Reliability Analysis Update

Transmission Expansion Advisory Committee

April 11, 2023

Changes to Existing Projects

ComEd Transmission Zone: Baseline Crete-St. John 345 kV Area Improvement

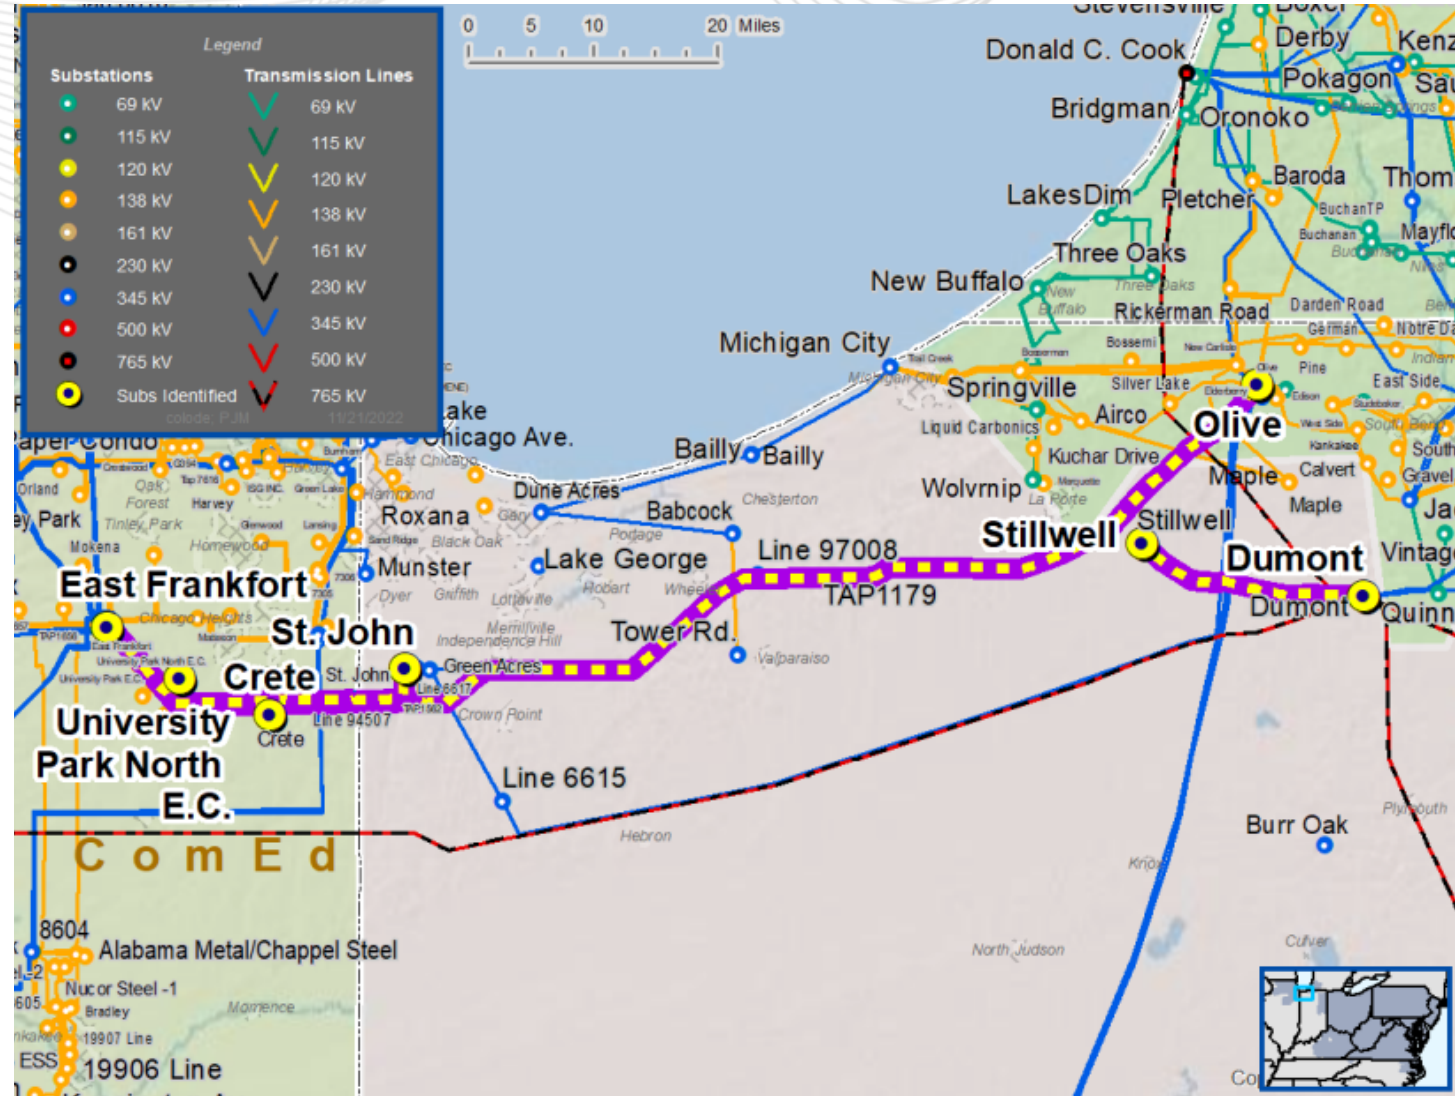
- Replace E. Frankfort 345 kV circuit breaker “9-14” with 3150A SF6 circuit breaker. **(B3775.5)**– ComEd (\$3.27 M)
- Perform sag study mitigation work on the Dumont-Stillwell 345 kV line (remove a center-pivot irrigation system from under the line allowing for the normal and emergency ratings of the line to increase, **replace two structures and modify a third structure**). **(B3775.6)**– AEP (\$0.22 M ~~\$2.22M~~ **\$2.22M**)

- Upgrade the limiting element at Stillwell or Dumont substation to increase the rating of the Stillwell-Dumont 345 kV line to match conductor rating. **(B3775.7)**– AEP (~~\$2 M~~ **\$1M**)

ComEd Transmission Zone: Baseline Crete-St. John 345 kV Area Improvement

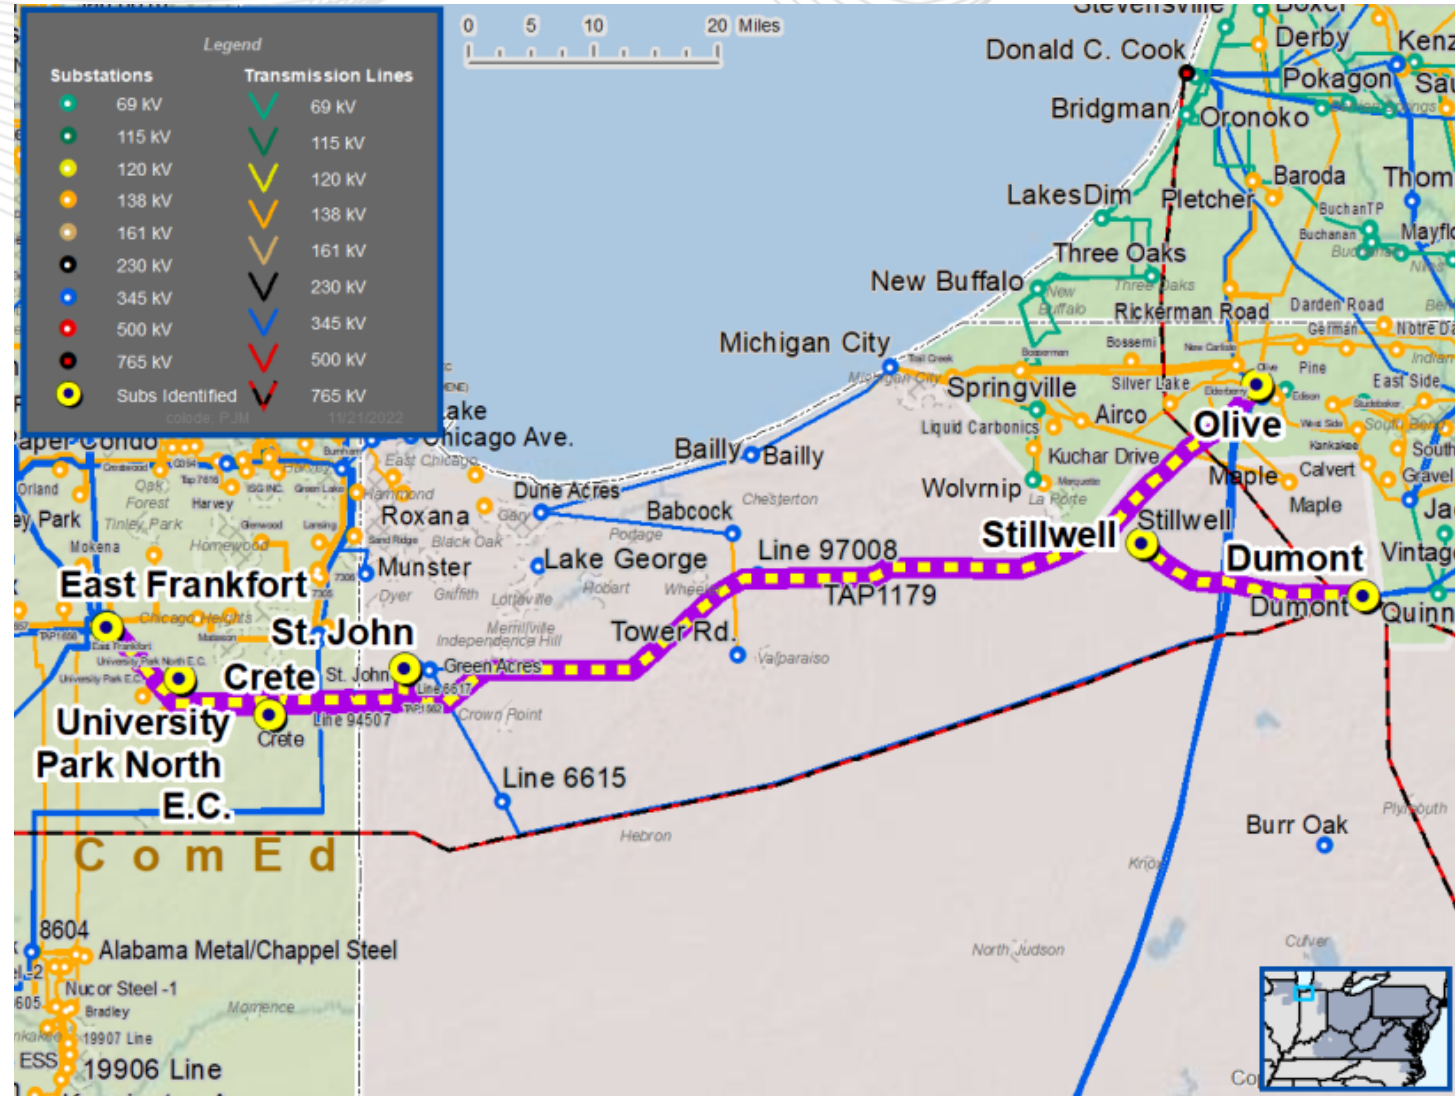
- B/C Ratio: ~~1.99~~ 1.92
- Congestion solved: 87%
- 15-years Net Load Payment Savings: \$169.83 million
- 15-years PJM CO2 Decrease: 556,740 metric tons

Total Estimated Cost: ~~\$73.88M~~ 76.66M
